MIAMI BEACH

Staff Report & Recommendation

Historic Preservation Board

SUBJECT: HPB23-0591, **1509 and 1515 Washington Avenue and 1500 Collins Avenue.**

Haddon Hall Hotel photograph, ca. 1941

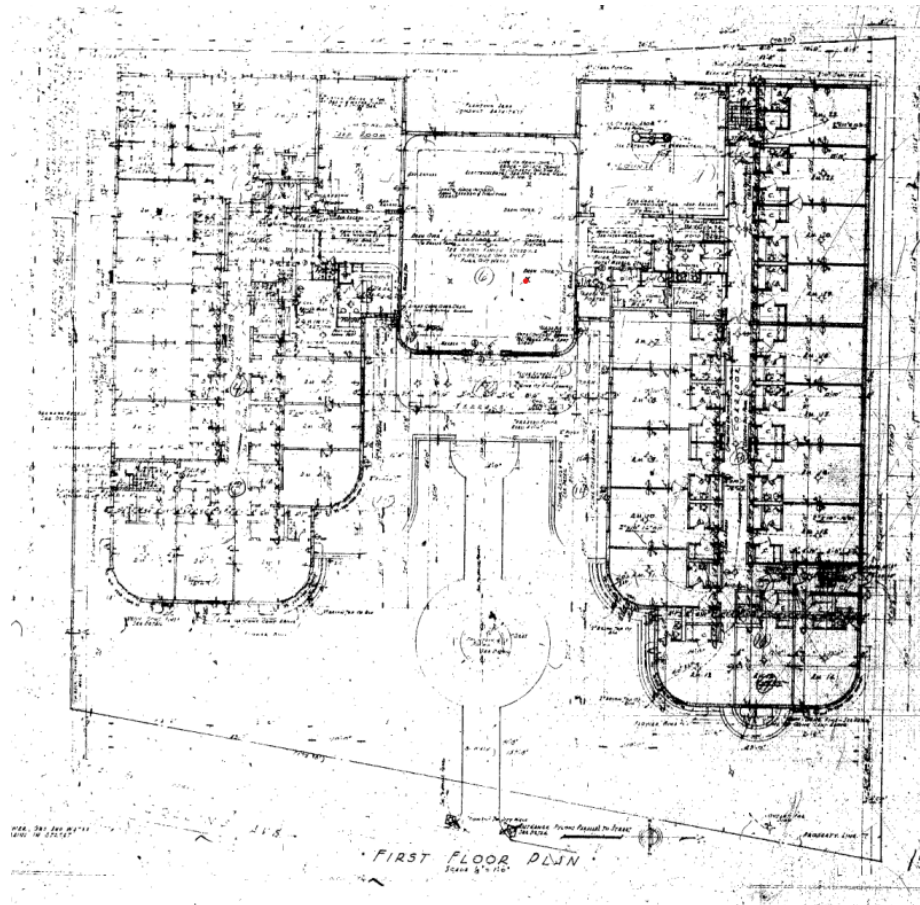
The Haddon Hall Hotel, designed by architect L. Murray Dixon and built in 1941, is an outstanding example of the Streamline Moderne style of architecture. In 2014, the Board approved the comprehensive renovation and restoration of the building, which incorporated significant improvements to the front yard area as well as the restoration of the lobby and ancillary public spaces. The applicant is proposing several significant modifications to the historic building including the following:
